Q. **Reference: Schedule 7: Capital Programs and Projects, Program 1: Wood Pole Line Management (2026)**

Chart 1: Asset Condition

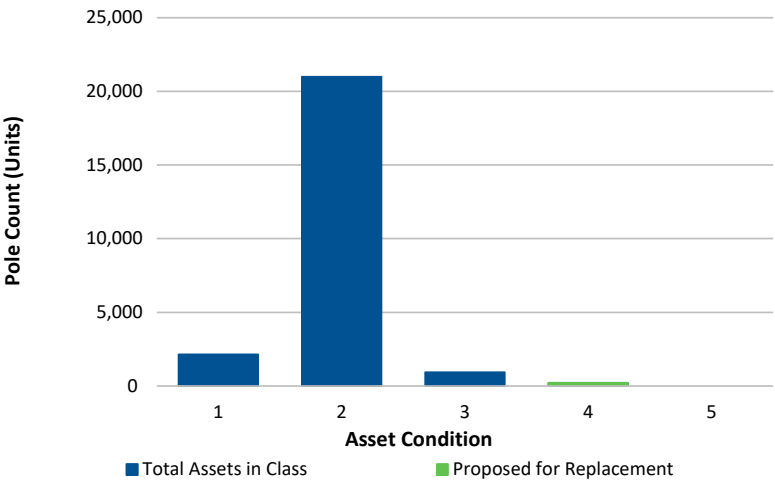
Page 8, Chart 1.

- a) Update Chart 1 to include poles that are rated as 4-Poor or 5-Severe/Hazardous to climb.
- b) The legends for Charts 1 and 3 are incomplete. Provide updated charts with the legends updated.
- c) In Project 6 (Relocate Section of Line (2026-2028) TL220) Hydro states on page 5 that “23 of the 109 poles in this section are currently rated as 4.” Please confirm if TL220 is included in Hydro’s annual Wood Pole Line Management System.

- A. a) Newfoundland and Labrador Hydro (“Hydro”) notes that Charts 1 to 3 were incorrect within the Wood Pole Line Management Program proposal. Please refer to the updated Chart 1, revised to include poles rated as 4-Poor and 5-Severe/Hazardous to Climb, and an updated legend. Hydro notes that there are currently no poles rated as 5.
- Revised Charts 2 and 3, with updated legends, are also included.
